ADDENDUM NUMBER TWO

SWIM TEAM LOCKER ROOM RENOVATIONS
UNIVERSITY OF SOUTH CAROLINA
COLUMBIA, SOUTH CAROLINA

DATE OF ISSUE: May 12, 2014

SKETCH NO: **SKE1**

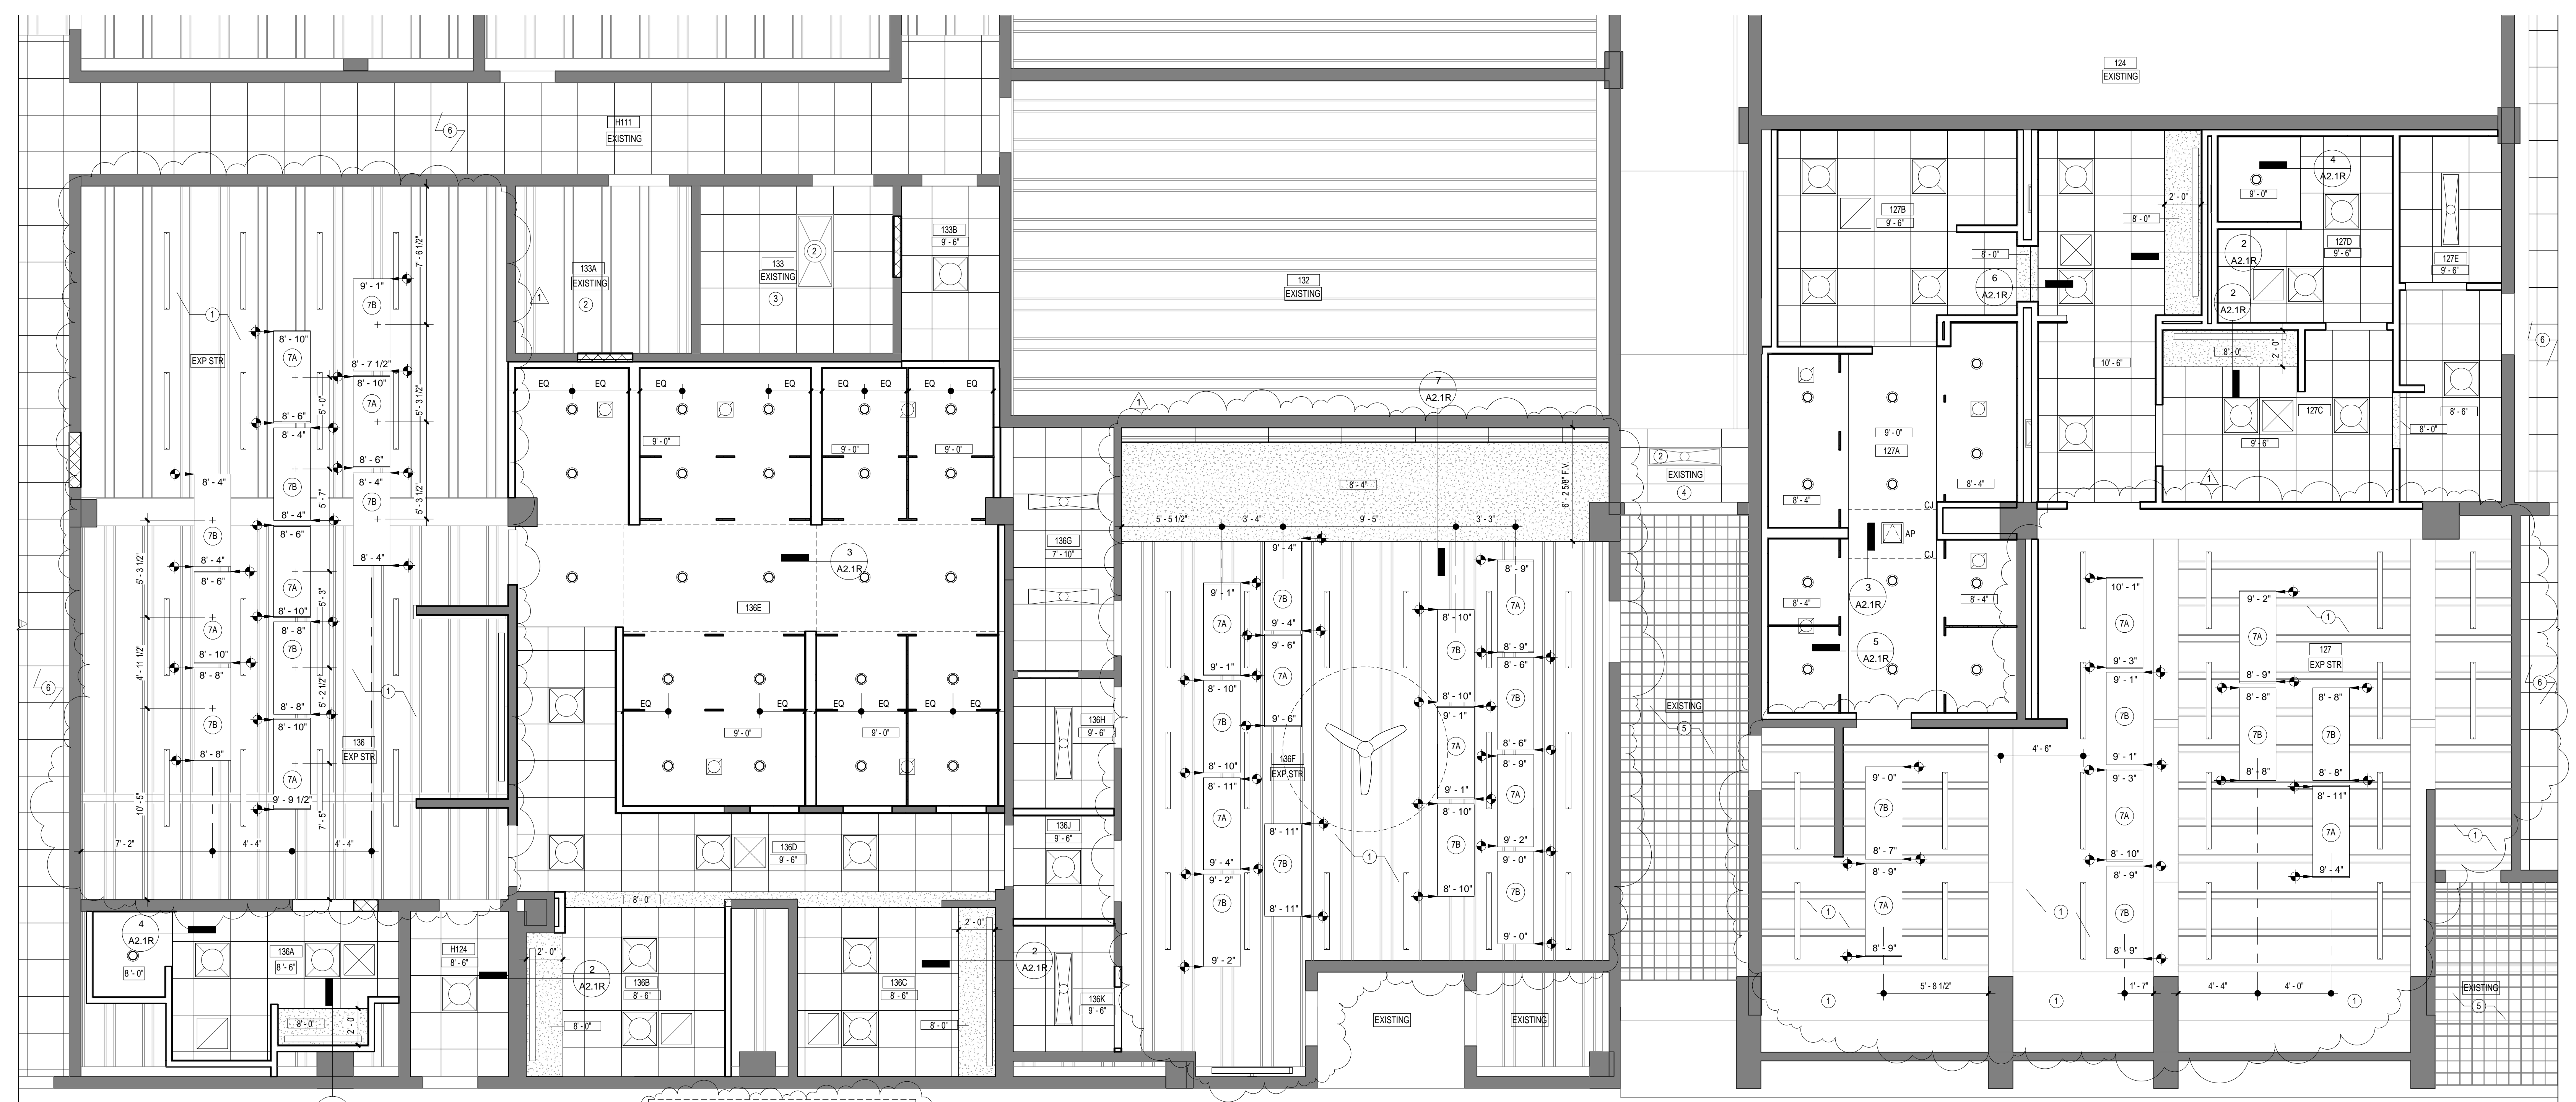
1. **Revision:** Delete Sheet A2.1 and E2.1 from Bid Documents. Replace with attached A2.1R and E2.1R. See revised base bid lighting layout in Women's Locker Room 136, Team Room 136F, and Men's Locker Room 127. See attached sketch SKE1 for light fixture schedule revisions.
2. **Revision:** Add Alternate No. 3 to Bid Documents. Add sheets A2.1A and E2.1A to Bid Documents. Provide Alternate No. 3 lighting layout in Women's Locker Room 136, Team Room 136F, and Men's Locker Room 127. See attached sketch SKE1 for light fixture schedule revisions.
3. **Revision:** Delete Sheet A3.3 from Bid Documents. Replace with attached A3.3R. See revised shower compartment/ shower curtain layouts and heights.

Symbol	Type Mark	Description	Manufacturer	Model	Optical Element	Mounting	Voltage	Lamps
	A	2'x2' FLUORESCENT GRID TROFFER, WET LISTED	LITHONIA	WRT G317 A12125V MVOLT GEB10IS	.125 ACRYLIC LENS	GRID	277 V	3 - 17W T8 / 841
	AE	2'x2' FLUORESCENT GRID TROFFER, 2 LAMPS, BATT. PACK INCLUDED, WET LISTED	LITHONIA	WRT G317 A12125V MVOLT GEB10IS EL14DW	.125 ACRYLIC LENS	GRID	277 V	3 - 17W T8 / 841
	B	1'x4' SURFACE MOUNTED FLUORESCENT FIXTURE	LITHONIA	LB 232 MVOLT GEB10IS	ACRYLIC LENS	CEILING	277 V	2 - 32W TB / 841
	C	WET LISTED LED DOWNLIGHT	LITHONIA	DOM6 LED 600L 40K DL61	GLASS LENS	CEILING	277 V	LED (15.6W, 500 LUMENS, 840)
	CE	WET LISTED LED DOWNLIGHT	LITHONIA	DOM6 LED 600L 40K DL61 ELRB722	GLASS LENS	CEILING	277 V	LED (15.6W, 500 LUMENS, 840)
	D	FLUORESCENT PERIMETER SYSTEM FIXTURE	FOCAL POINT	FW3 NS 1T8 1C 277 E RC SS WH *LENGTH*	NONE	RECESSED	277 V	1 - 32W TB / 841
	F	SMALL STRUCTURAL TRUSS SYSTEM - LINEAR FLUORESCENT FIXTURE WITH NATATORIUM FINISH	SPI LIGHTING	LFL 1454	-	SUSPENDED TO 9'-6" AFF	277 V	4 - 54WT5HO / 841

F2	DIRECTIONAL FLOOD LIGHT SUPPORTED FROM LIGHTRUSS SYSTEM	CONTECH LIGHTING	8051 VT M 4 N-S WITH PIPE CLAMP	-	TIED TO LIGHTRUSS SYSTEM	277 V	LED (14W, 1000 LUMENS, 840)
	FE	SAME AS TYPE "F" EXCEPT WITH INTEGRAL 1400-LUMEN BATTERY PACK.	SPI LIGHTING	LFL 1454 EMI	-	SUSPENDED TO 9'-6" AFF	277 V	4 - 54WT5HO / 841
	G4	4' WET-LISTED VANITY FIXTURE	AXIS LIGHTING	WBW S 4 T5 2 AP 277 ERS 1	SATIN LENS	WALL MOUNT ABOVE VANITY	277 V	2 - 28W T5 / 840
	G6	6' WET-LISTED VANITY FIXTURE	AXIS LIGHTING	WBW S 6 T5 2 AP 277 ERS 1	SATIN LENS	WALL MOUNT ABOVE VANITY	0 V	4 - 21W T5 / 840
	G8	8' WET-LISTED VANITY FIXTURE	AXIS LIGHTING	WBW S 8 T5 2 AP 277 ERS 1	SATIN LENS	WALL MOUNT ABOVE VANITY	0 V	4 - 28W T5 / 840
	H	4' HORIZONTAL WALL MOUNT FIXTURE WITH NATATORIUM FINISH	SPI LIGHTING	SFWZ 1 F28 120 4' SBC 004	SATIN LENS	WALL MOUNT ABOVE VANITY	277 V	1 - 28W T5 / 840
	J	4' SUSPENDED FLUORESCENT INDIRECT FIXTURE	AXIS LIGHTING	WBDI S 4 T5HO 0 2 AP UNV E 2 SA#	SATIN LENS	SUSPENDED TO 9'-6" AFF	277 V	2 - 54WT5HO / 841

JE	SAME AS TYPE "J" EXCEPT WITH INTEGRAL EMERGENCY BATTERY PACK	AXIS LIGHTING	WBDI S 4 T5HO 0 2 AP UNV E 2 SA# B14	SATIN LENS	SUSPENDED TO 9'-6" AFF	277 V	2 - 54WT5HO / 841
	X	LED EXIT SIGN WITH NiCad BATT., RED LETTERS AND WHITE CANOPY, 1 FACE	LITHONIA	LQM S W 3 R 120/277 ELN	NONE	AS SHOWN	277 V	L.E.D. INCLUDED

DRAWN BY: [Blank] CHECKED BY: [Blank]
 AUTHORIZED: [Blank]
 DATE: 05.12.14
 PROJECT NO.: H27-Z158
 DRAWING NO.: A2.1A

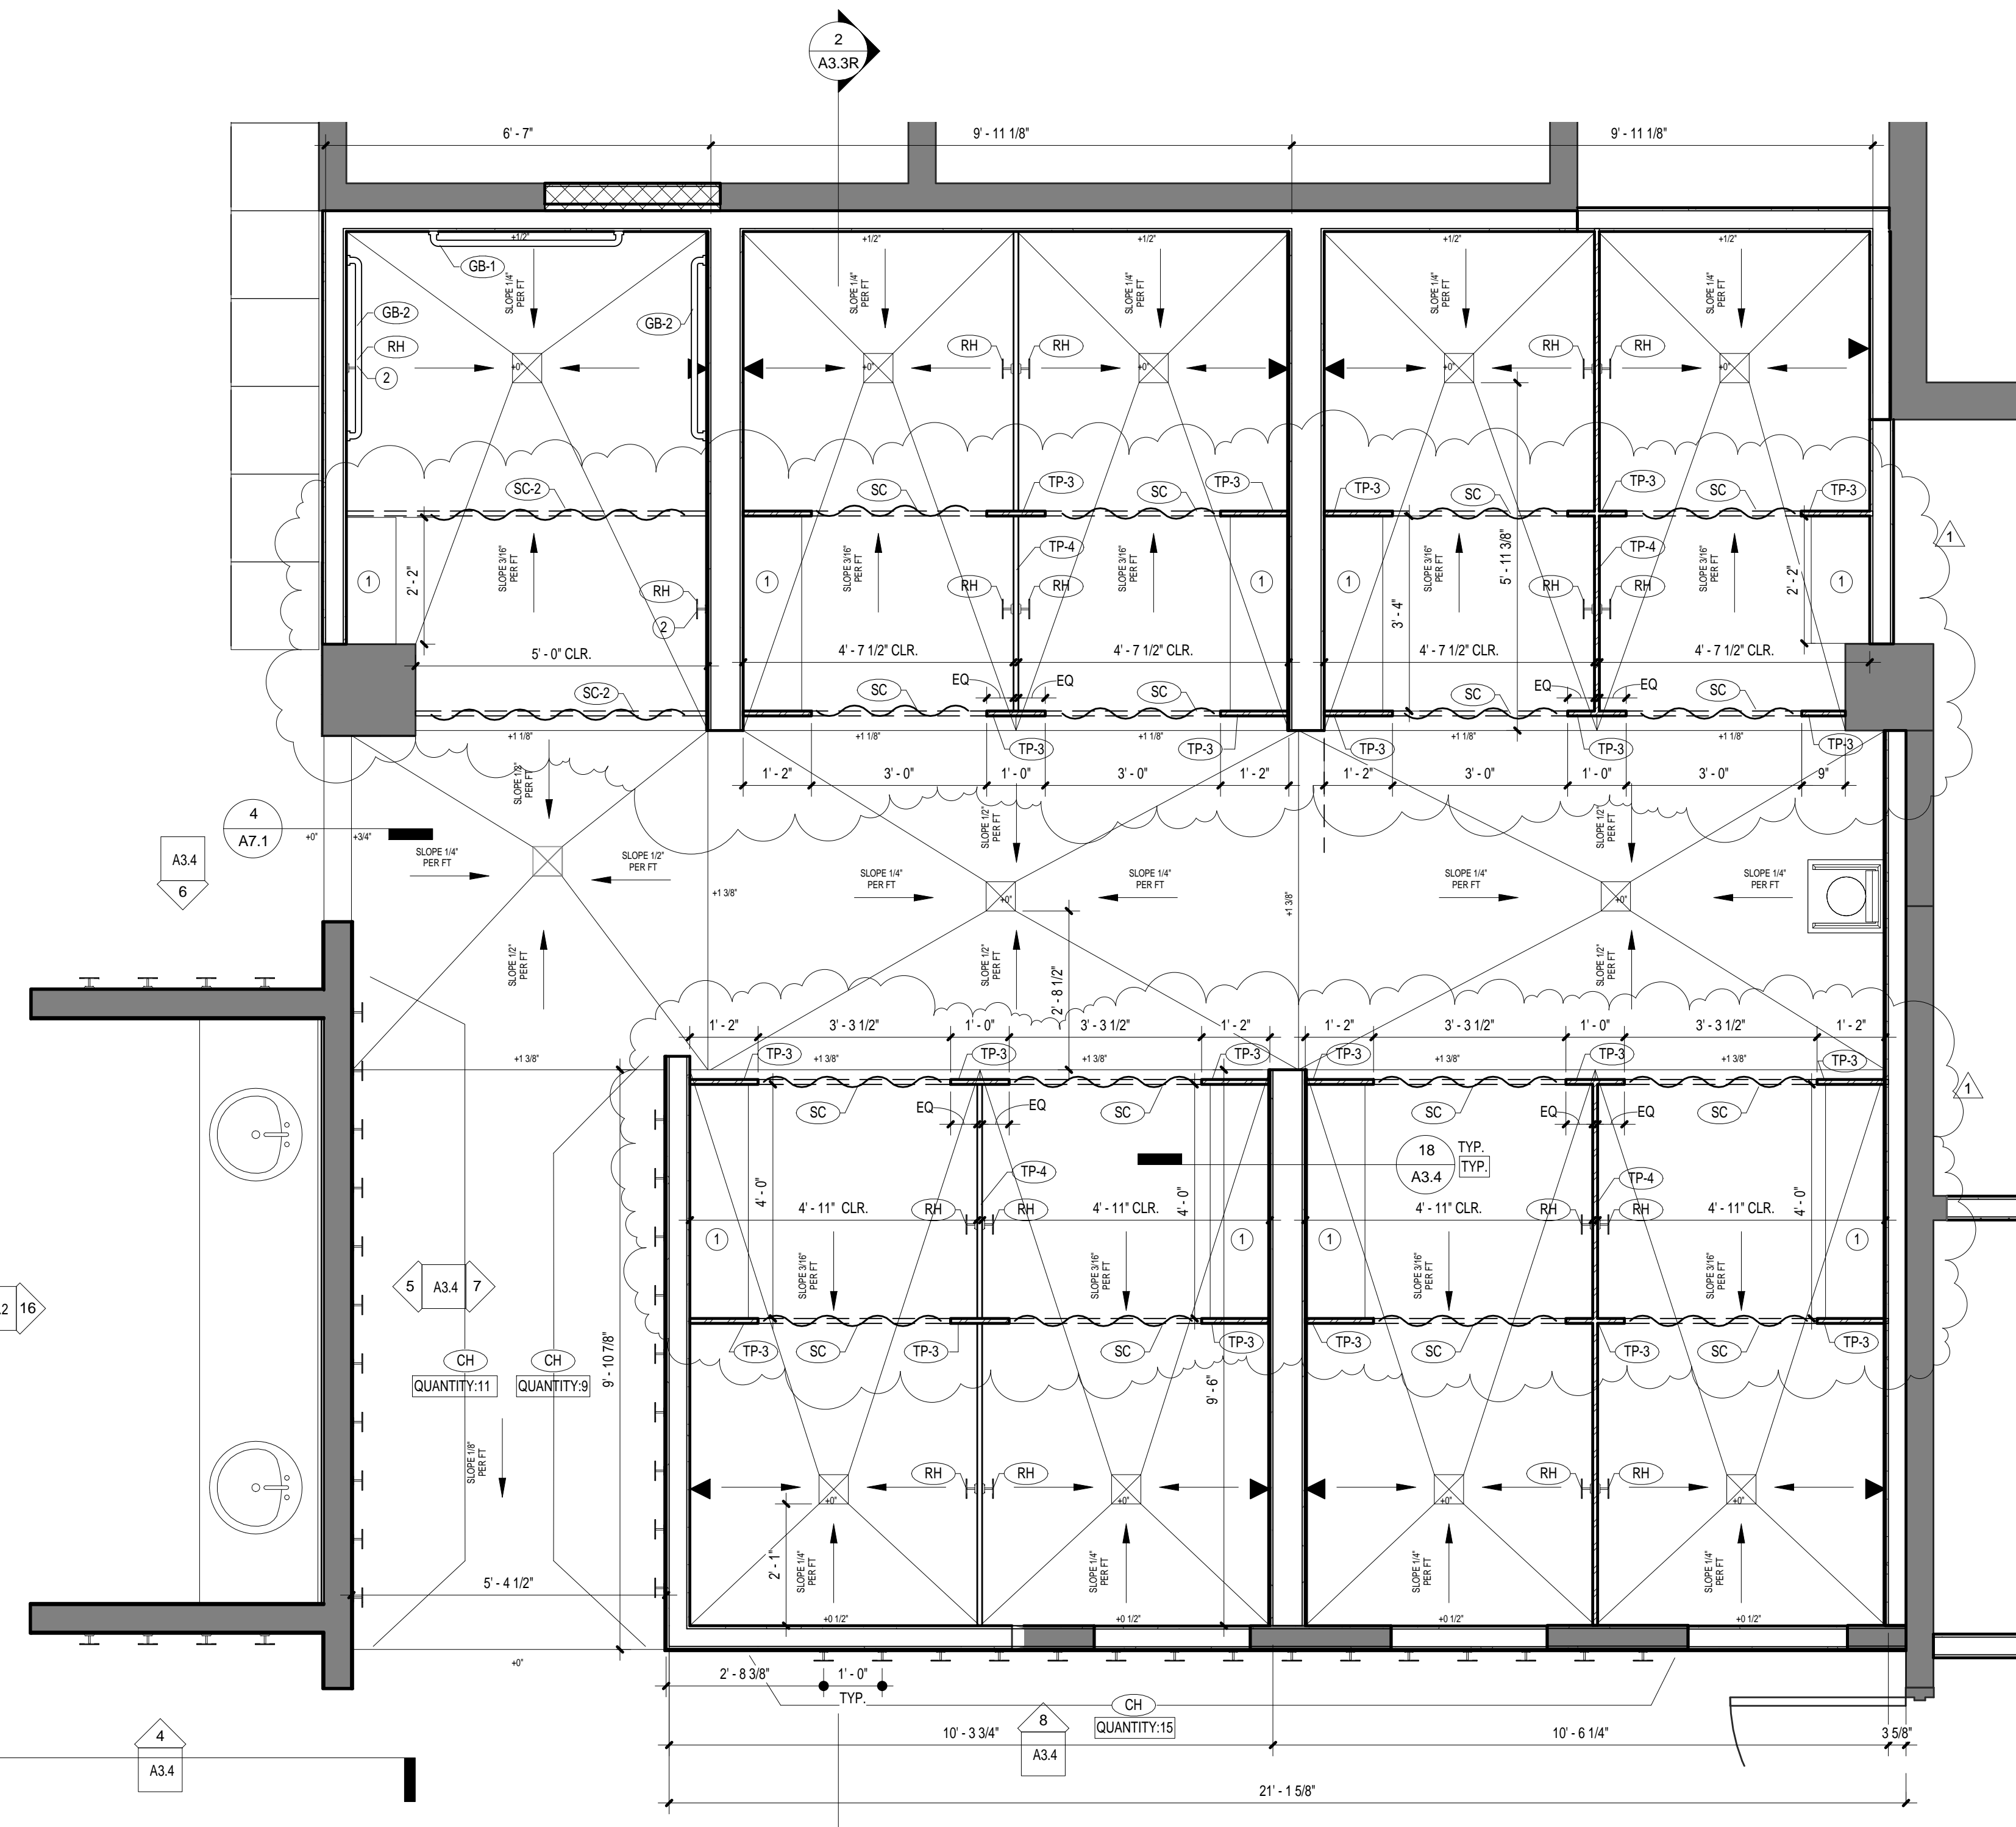
C. Alternate No. 3: Provide Alternate Lighting Layout at Women's Locker Room 136, Team Room 136F, and Men's Locker Room 137. See A2.1A, E2.1A, and SKE1.

ALTERNATE NO. 3
 PROVIDE LIGHTRUSS LAYOUT AS SHOWN ON A2.1A AND E2.1A. SEE ELECTRICAL FOR FULL SCOPE OF WORK INFORMATION. PROVIDE LIGHTRUSS IN LOCKER ROOMS AND TEAM ROOM IN LIEU OF BASE BID SUSPENDED FLOURESCENT INDIRECT FIXTURE.
